Technical Service Bulletin No. 31

Created by: Lab.gruppen AB Service Department

Date: 2014-04-03

Reference no: 22N630VMKP7.5

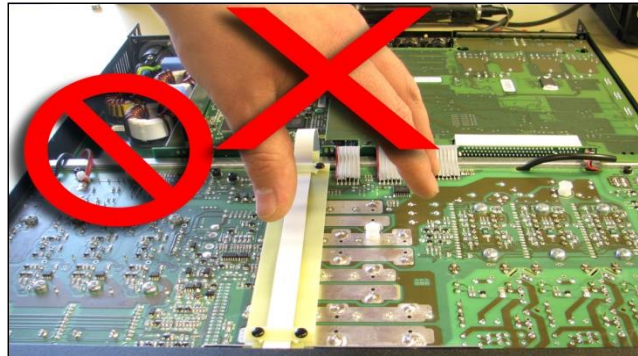
C600, C601, C700, C701, C810 and C811 with the below listed components

Part number	description	Amount
22N630VMKP7.5	EVOX-RIFA Capacitor Polypropylene 22n 630V Mkp 7.5mm	6

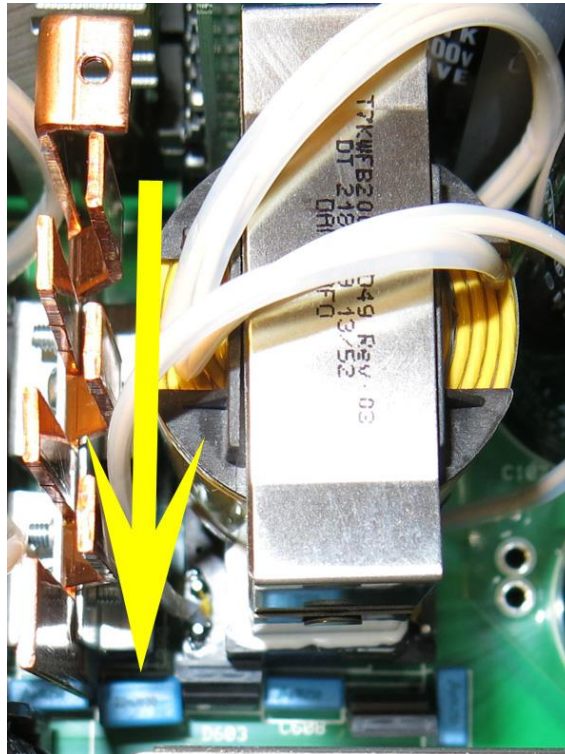
| 6. | Check if you have the faulty capacitor. The faulty capacitor is a color grey Vishay capacitor |

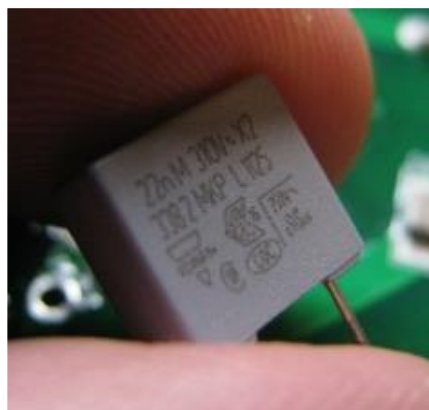
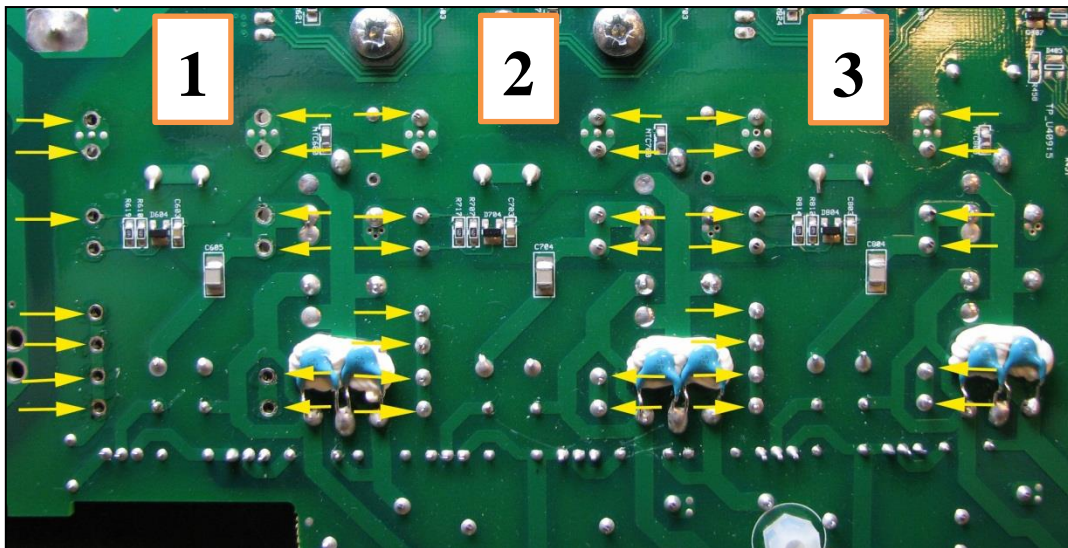
| 7. | This is the faulty capacitor it's the grey vishay capacitor. If you find this capacitor follow the instructions below on how to replace them |

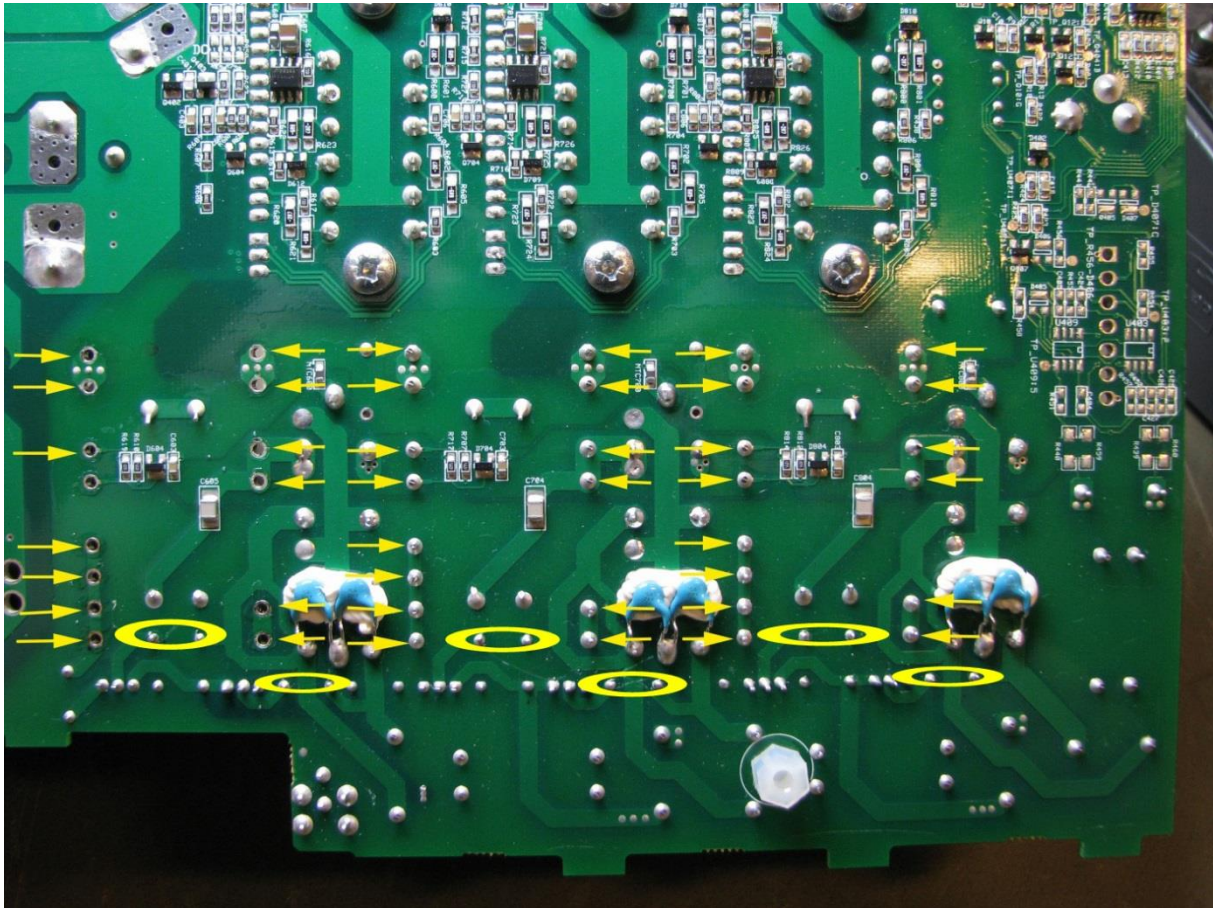
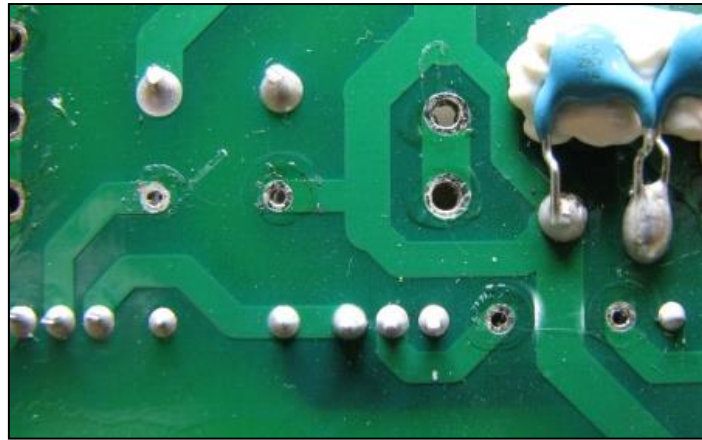
11. Remove the grey Vishay 22n capacitors from position C600, C601, C700, C701, C810 and C811.
The oval rings show the soldering pins where the capacitors are placed.

13. Mount the specified evox rifa 22n capacitors on the positions C600, C601, C700, C701, C810 and C811.
